Serial No. 10/733,717
Office Action Dated: 05/07/09
Response to Office Action Dated: 11/06/09

AMENDMENTS TO THE DRAWINGS

REMARKS

FIG. 14

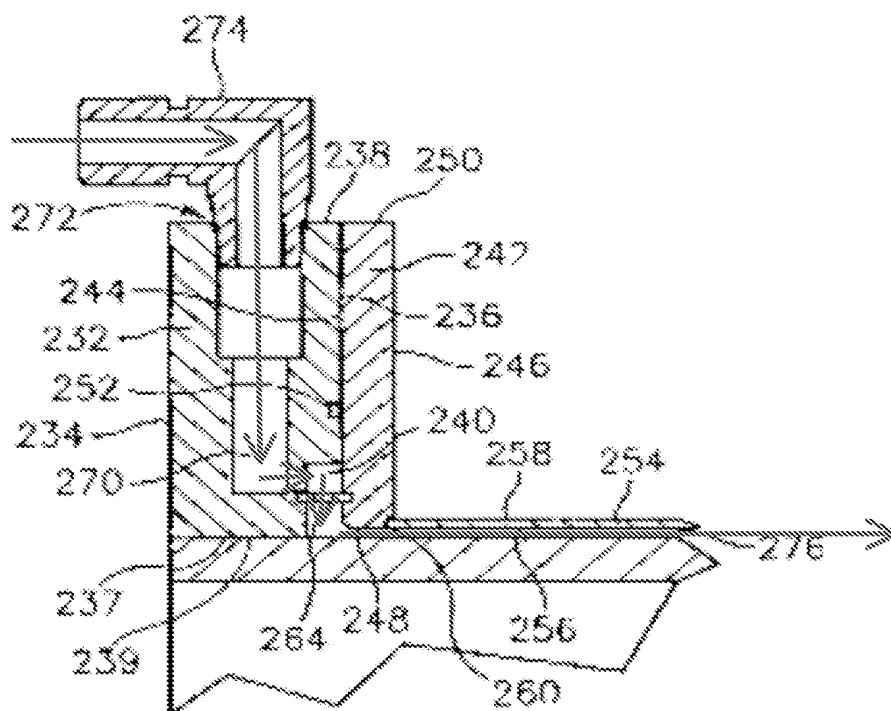
Additionally, the Examiner asserts that it is not clear from the disclosure of paragraph [0043] how the cooling fluid that enters the flange travels all the way to the cooling gas outlet. Applicant respectfully disagree with the Examiner’s assertion. Specifically, paragraph [0043] of the Specification clearly describes how the cooling flow enters the flange at ports 272 through fittings 274. The cooling flow then proceeds through passageways 270 and metering ring 264 into the annular space 276, to be discharged from the cooling gas outlet 278. (Specification, paragraph [0043]). This cooling flow path is clearly seen in Figures 13 and 14, as illustrated below in amended Figure 14.

Furthermore, Applicant respectfully submits that the bolts do not need to be shown in Figures 13 and 14, as asserted by the Examiner. (See Office Action, page 4). As the Examiner notes in the Office Action, Figure 13 is a sectional view of Figure 12. Figure 14 is an enlarged view of a portion of Figure 13. It is clear from Figure 12 that neither the bolts nor the bolt holes are in the section through which Figure 13 is taken. In fact, the bolts are not even shown in Figure 12. Therefore, the bolts should also not be shown in Figure 13.

Regarding the objections to the Drawings, Applicant respectfully submits that the current amendments to the claims, Specification and Drawings fully address the objections. Specifically, the first and second faces of claim 1 have been amended to recite “upstream and downstream faces” which are shown in at least amended Figure 14. Additionally, paragraph [0043] of the Specification has been amended to include a central aperture 239, which is shown in at least amended Figures 13 and 14. Claim 1 has been amended to replace “inboard surface” with “interior surface,” which is shown in at least amended Figure 14.

Additionally, Figure 13 has been amended to include the “upstream rim 260.” Accordingly, Applicant respectfully requests that the objections to the Drawings be withdrawn.
